SAFETY EVALUATION BY THE OFFICE OF NUCLEAR REACTOR REGULATION

SUPPORTING AMENDMENTS NO. 6 TO LICENSES NO. DPR-32 AND DPR-37

CHANGE NO. 21 TO TECHNICAL SPECIFICATIONS

SURRY POWER STATION UNITS 1 & 2

FIGURE 2.1-1 REACTOR CORE THERMAL & HYDRAULIC SAFETY LIMITS-
THREE LOOP OPERATION, 100% FLOW

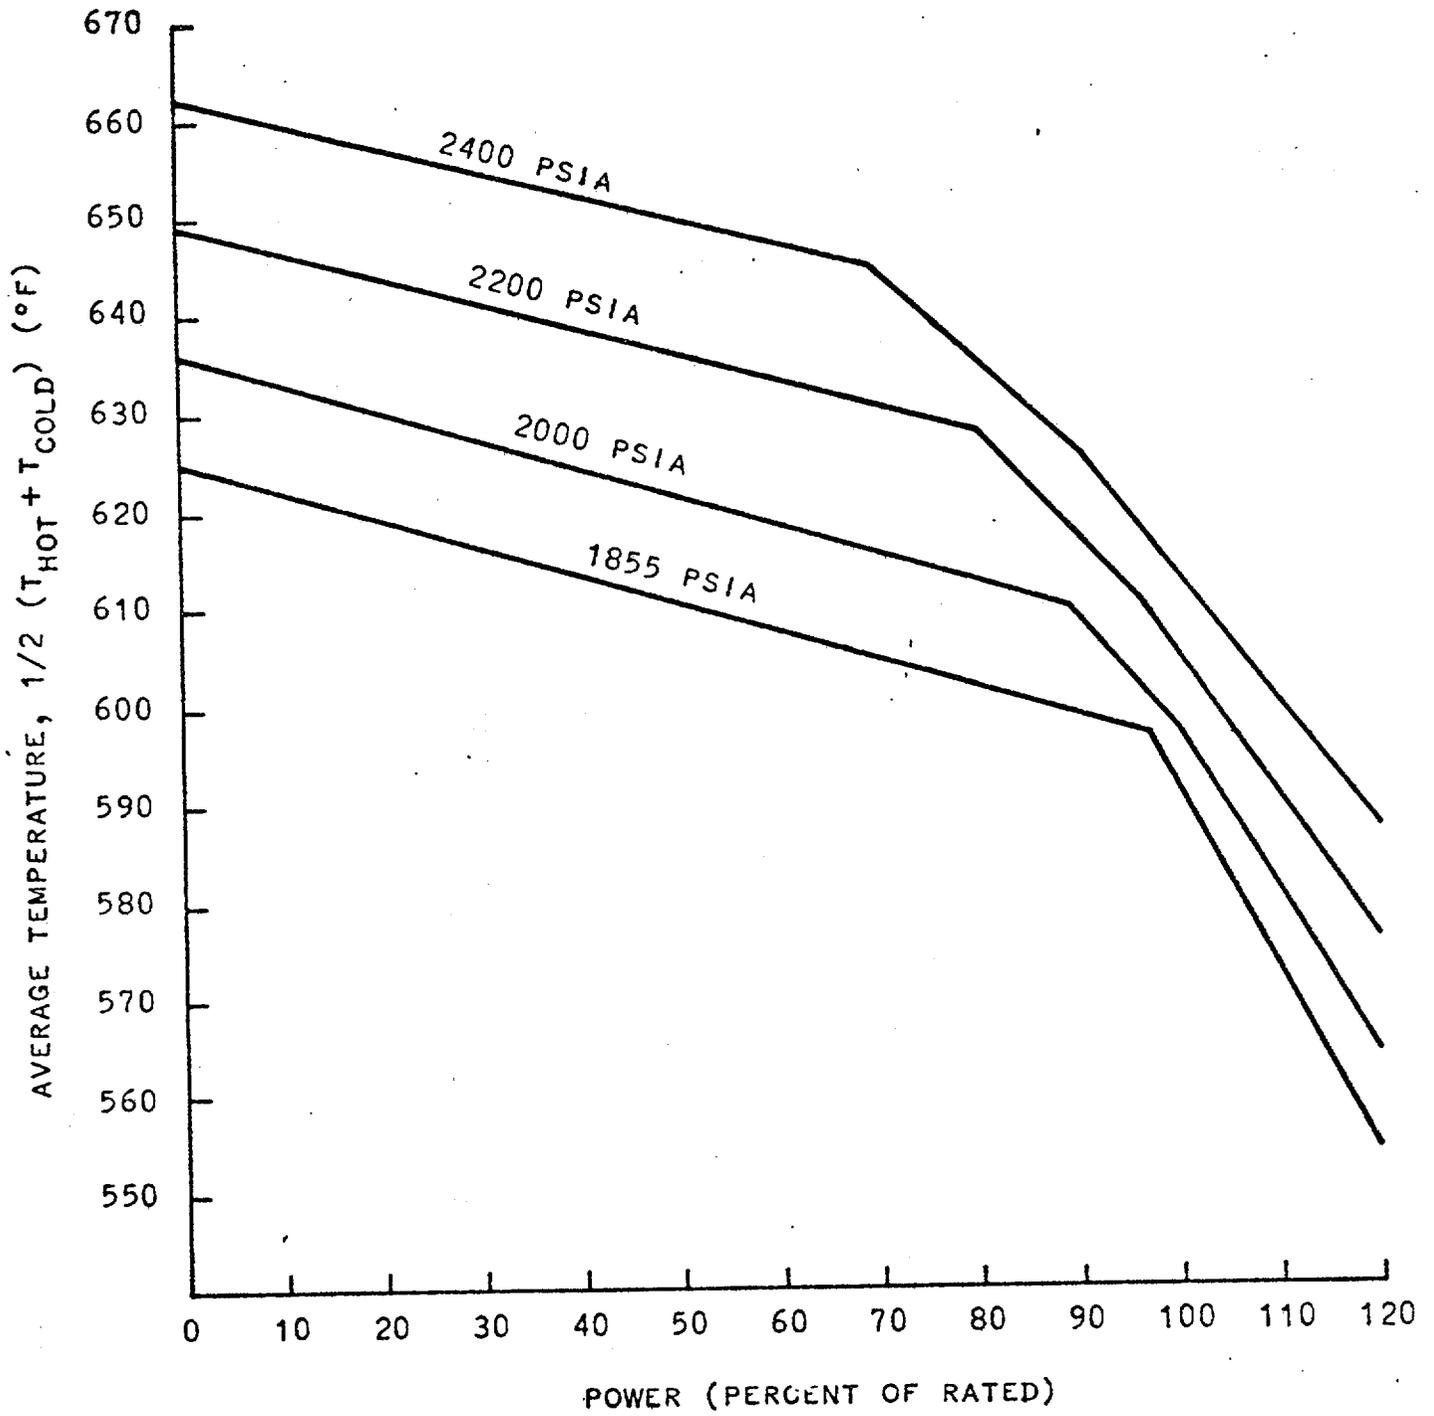
The curves of TS Figure 2.1-1 which show the allowable power level decreasing with increasing temperature at selected pressures for constant flow (three loop operation) represent limits equal to, or more conservative than, the loci of points of thermal power, coolant system average temperature, and coolant system pressure for which the DNB ratio is equal to 1.30 or the average enthalpy at the exit of the core is equal to the saturation value. The area where clad integrity is assured is below these lines. The temperature limits are considerably more conservative than would be required if they were based upon a minimum DNB ratio of 1.30 alone but are such that the plant conditions required to violate the limits are precluded by the self-actuated safety valves on the steam generators. The three loop operation safety limit curve has been revised to allow for heat flux peaking effects due to fuel densification.

TS Figures 2.1-1 through 2.1-3 are based on a $F_{\Delta H}^N$ of 1.55, a 1.55 cosine axial flux shape and a DNB analysis as described in Section 4.3 of the report Fuel Densification Surry Power Station, Unit 1 dated December 6, 1972 (including the effects of fuel densification). They also include an allowance for an increase in the enthalpy rise hot channel factor based on the expression:

FIGURE 2.1-2 REACTOR CORE THERMAL AND HYDRAULIC SAFETY LIMITS, TWO LOOP OPERATION, LOOP STOP VALVES OPEN

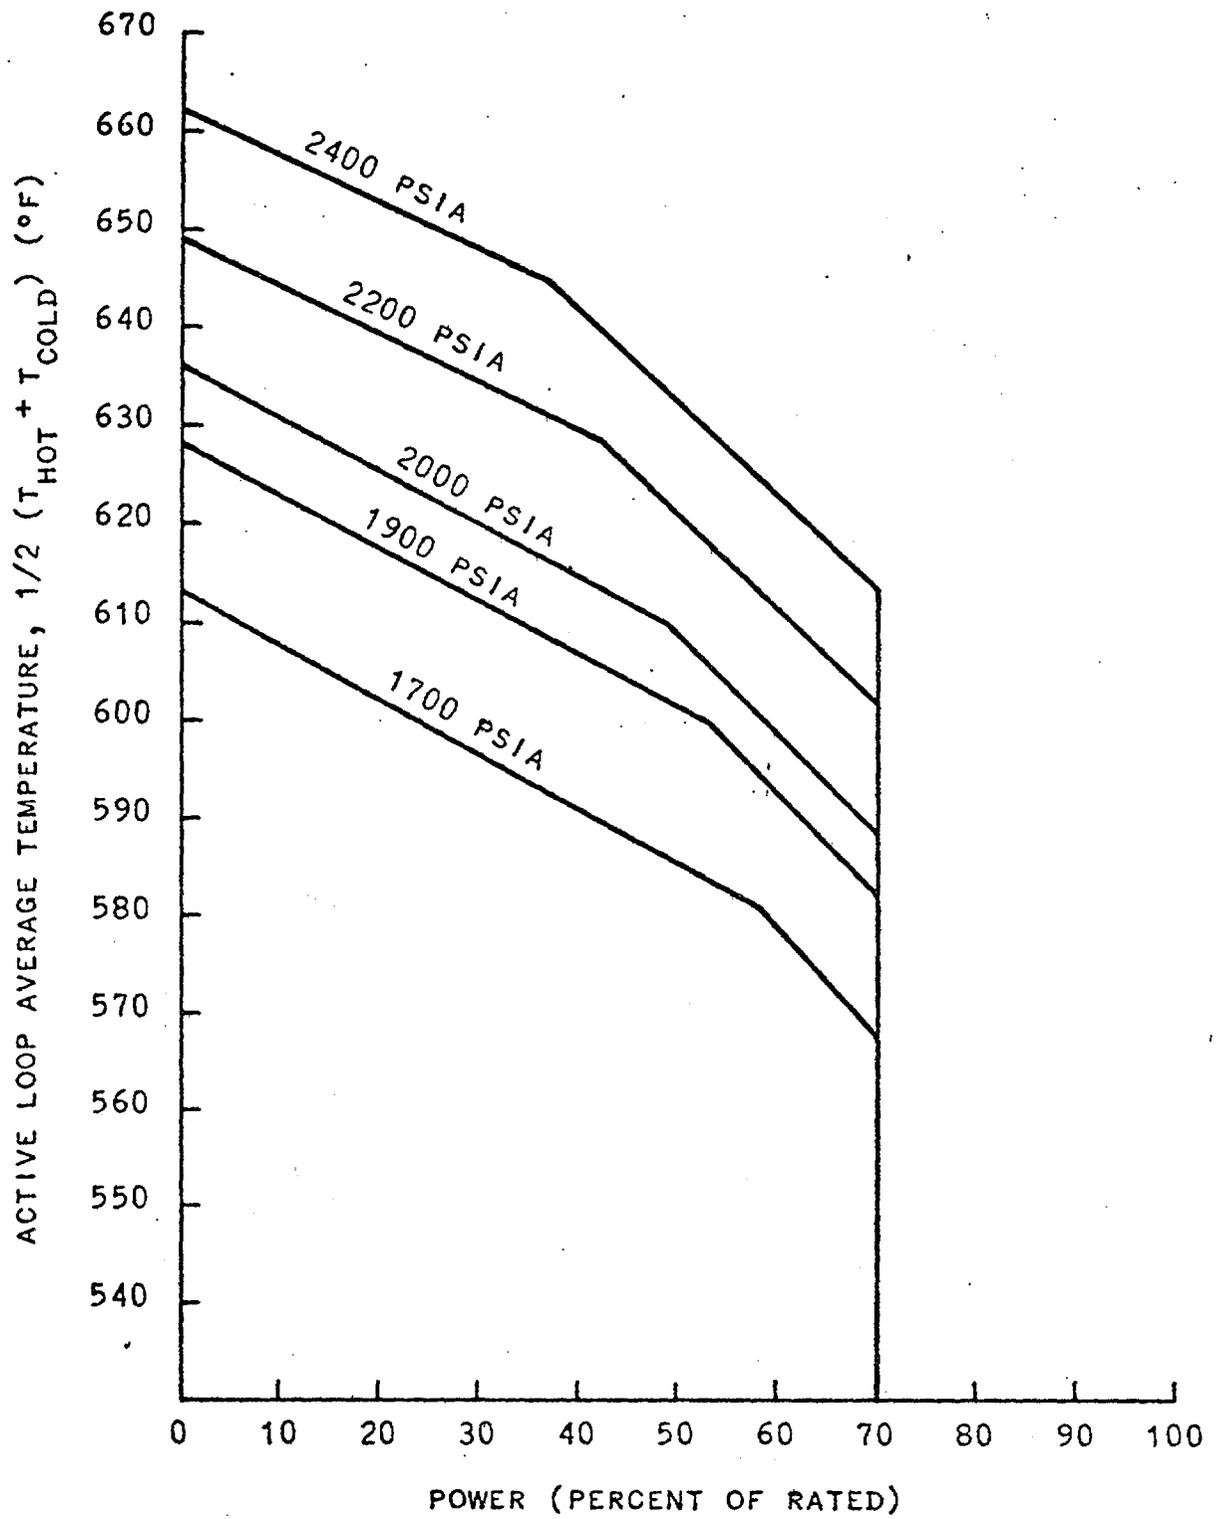
The curves of TS Figures 2.1-2 and 2.1-3 which show the allowable power level decreasing with increasing temperature at selected pressures for constant flow (two loop operation), represent limits equal to, or more conservative,

FIGURE 3.12-1B CONTROL BANK INSERTION LIMITS FOR NORMAL 3 LOOP OPERATION-UNIT NO. 2

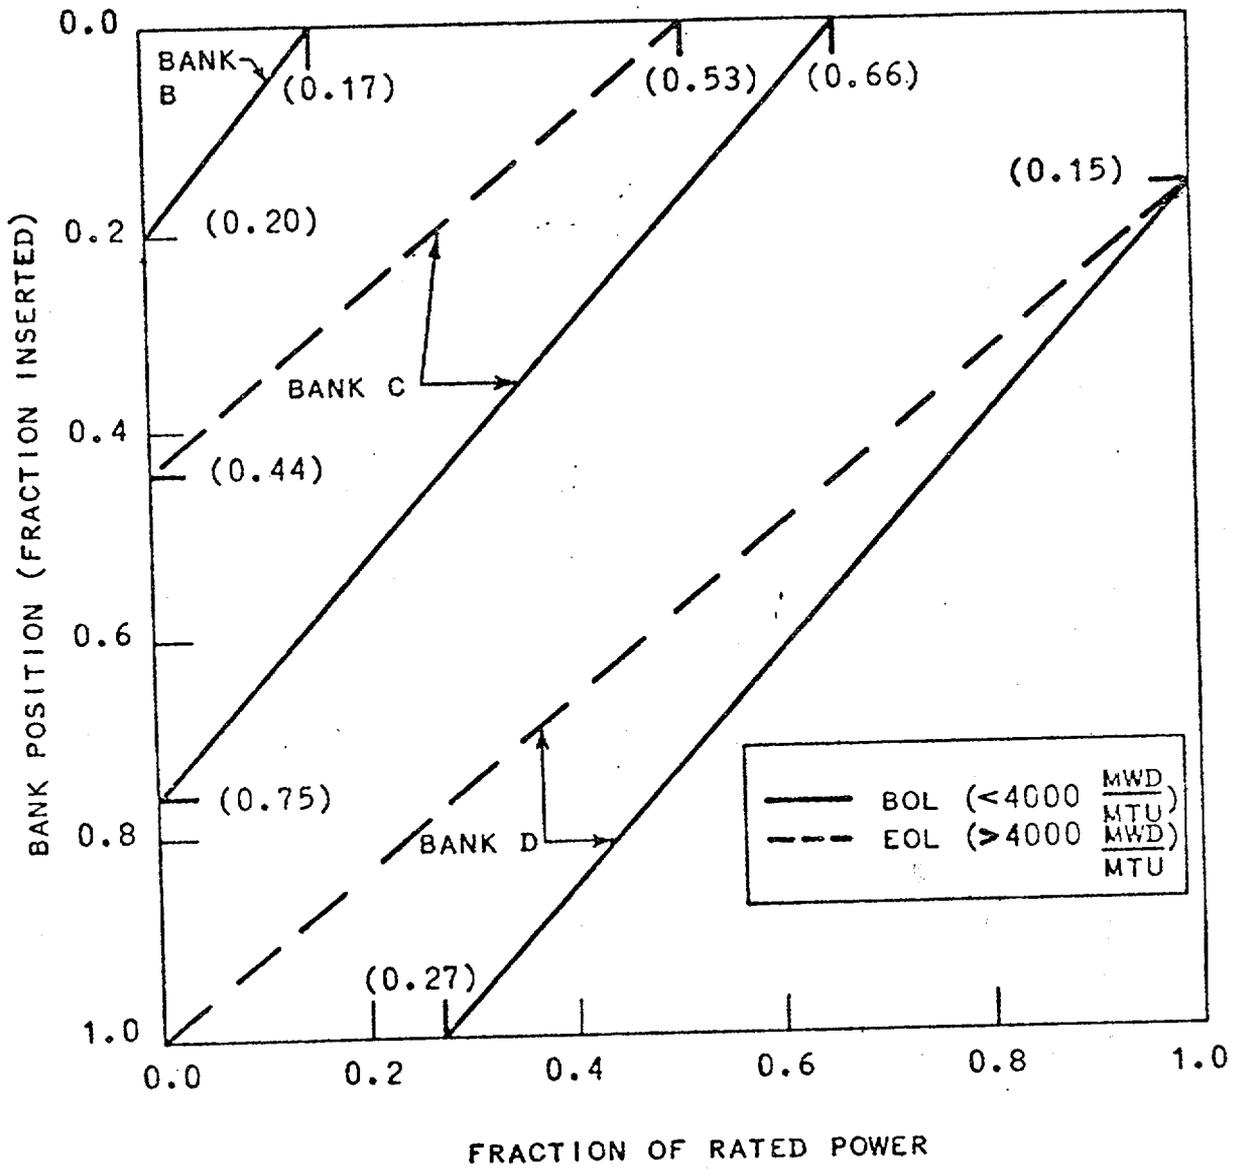
The changes to Section 3.12 proposed by the licensee in Technical Specification Change No. 27 involve replacement of Figures 3.12-1B and 4B, control rod insertion limits for three- and two-loop operation consistent with the Unit 2 cycle 2 reload analysis. The insertion limits maintain the shutdown margin throughout cycle life as well as maintaining potential ejected rod worth and power distribution within the limits used in the accident analysis and are acceptable as proposed.
